RE: Union Electric Company's 2005 Utility Resource Filing
Case No. EO-2006-0240

Case No. EO-2006-0240

MDNR Comments on AmerenUE's 12/5/05 IRP Compliance Filing -Public Version

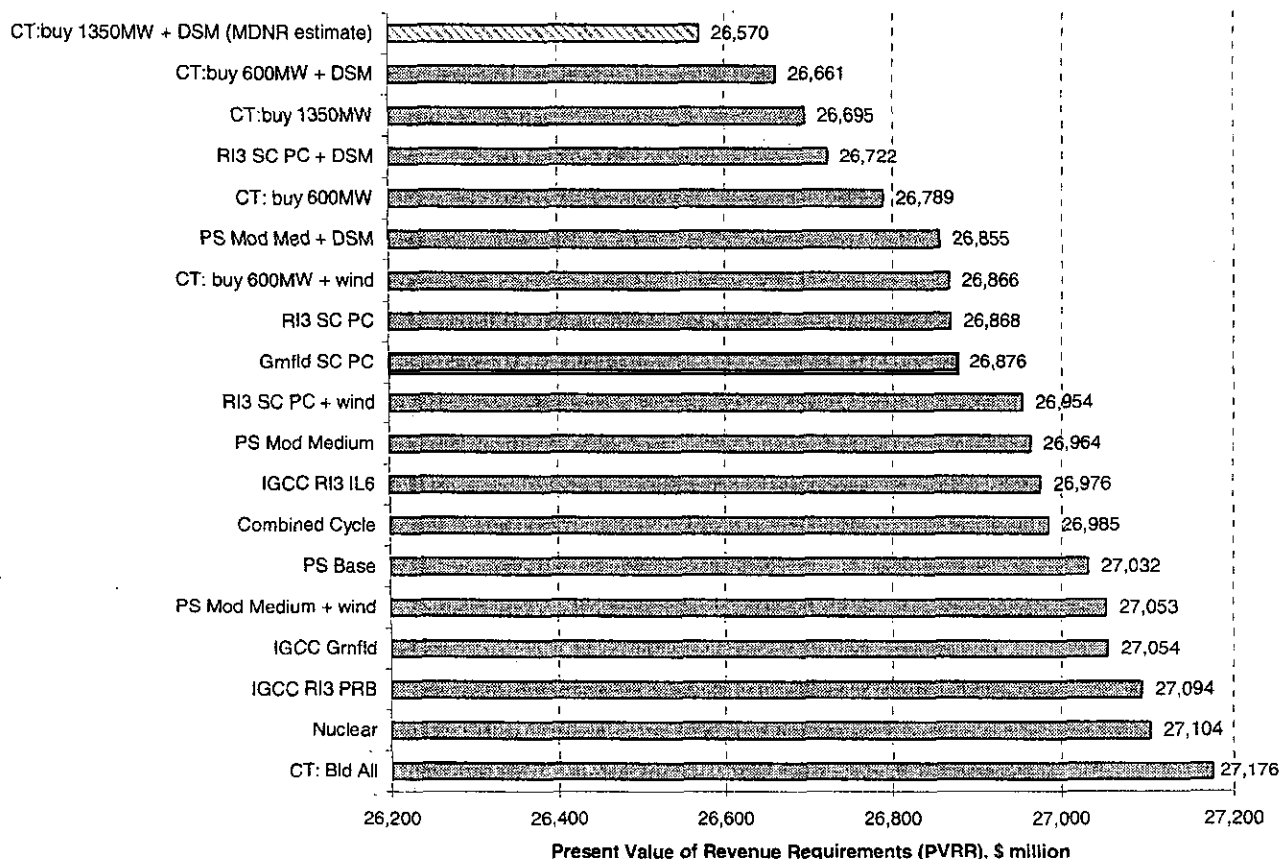
531 **AmerenUE does not adequately discuss its decision to combine all EE and DR**
532 **programs into one aggregate DSM implementation.**

533 AmerenUE's decision to combine all EE and DR programs into one aggregate DSM
534 implementation has at least two disadvantages:

- 535 ▪ It provides no basis for comparing the net benefits of different combinations of EE and DR
536 DSM programs.
- 537 ▪ It provides no basis for estimating the interaction of different combinations of EE and DR
538 DSM programs. Rule 4 CSR 240-22.050(6)B requires the utility to analyze the synergistic
539 effects and competitive effects from combining DSM programs. However, AmerenUE states
540 in its response to Data Request MPSC 0012 that it has not analyzed these interactive effects.
